TECHNICAL BULLETIN

QUICK & CRASH

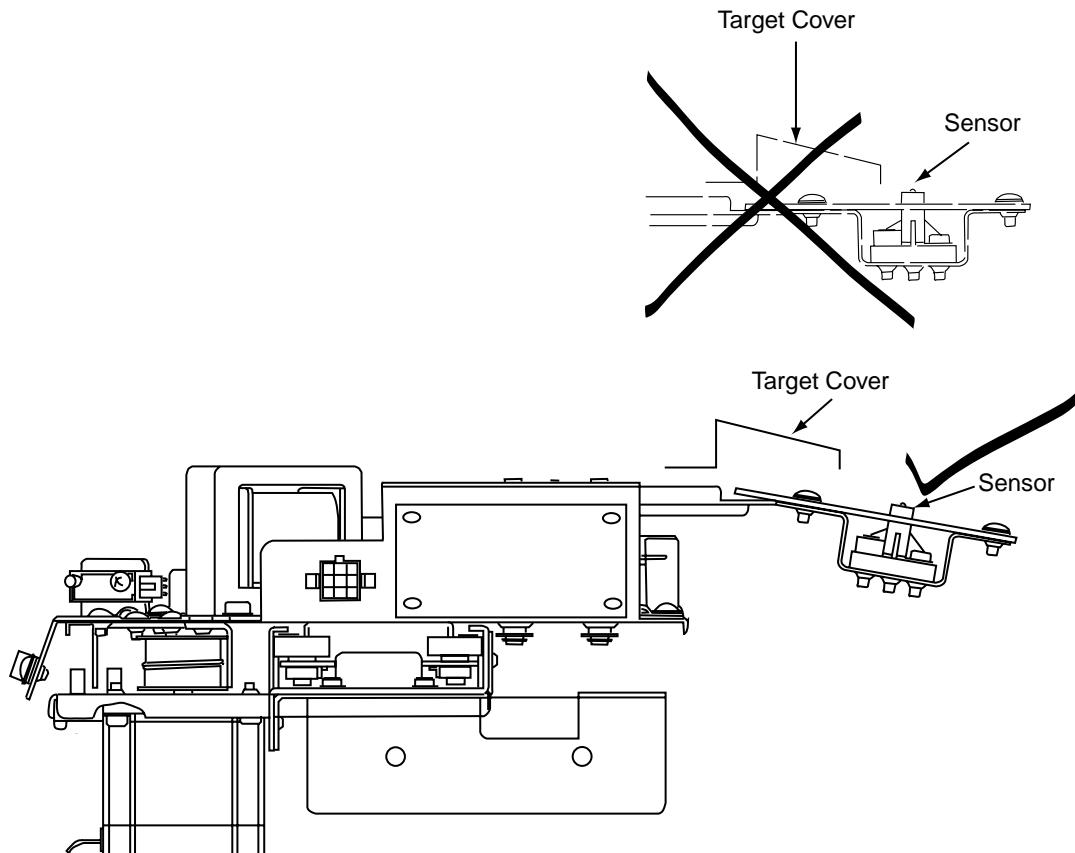
We have become aware of a possible problem on a small quantity of games recently shipped, whereby the Flat Target Photo Sensor may become damaged and fail to work.

The Flat Target should be angled downwards by approx.10°. On some games the Flat Target is horizontal and the Photo Sensor is hitting the Target Cover when the solenoid activates the target. This may cause the lens of the Photo Sensor to be damaged and destroy the sensor.

Please check both Flat Targets (upper & lower) to prevent possible future problems and maintain game income.

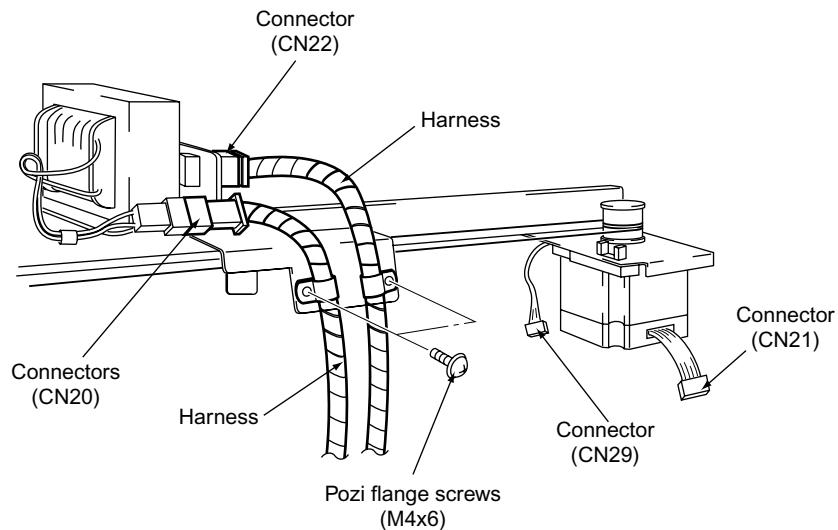
The Upper and Lower Target Assemblies are different.
Ensure that they are replaced in the correct positions

1. Remove the upper rear door from the Target Cabinet.
2. Disconnect the connectors (CN20) and (CN22), remove 2off pozi flange head screws (M4x6) to release the harnesses.

3. Disconnect the connectors (CN21) and (CN29).
4. Remove 4off (2ea left and right) flange socket head screws (M5x8) and remove the Flat Target Assy.

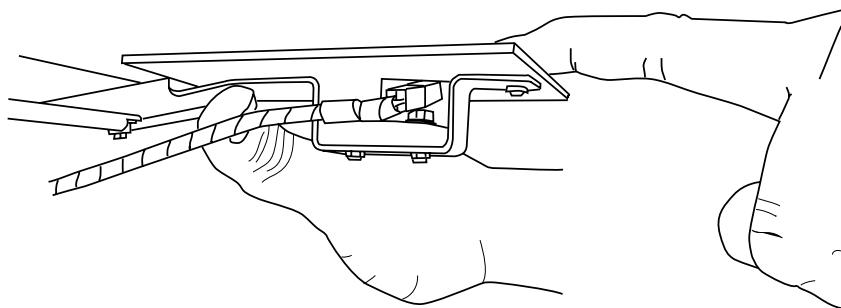
Note: When removing the Flat Target Assy from the cabinet, slide the motor side of the Flat Target Assy in the direction of the arrow, as shown in the diagram below, being careful that it does not come in contact with any other parts of the Target Cabinet.

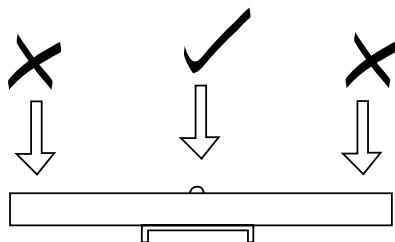
5. If the Target needs adjusting, bend downwards by placing a thumb underneath the rear of the target and pressing down at the front.

Note: Take care when bending the target not to twist it.

6. Refit the Target Assembly to the cabinet.
7. Operate the Target Solenoid by hand and check that the Photo Sensor is clear of the Target Cover by 5~10mm.
8. Refit the Upper Rear Door and test the game. (Refer to section 6-3 page 42 of the Operators Manual)
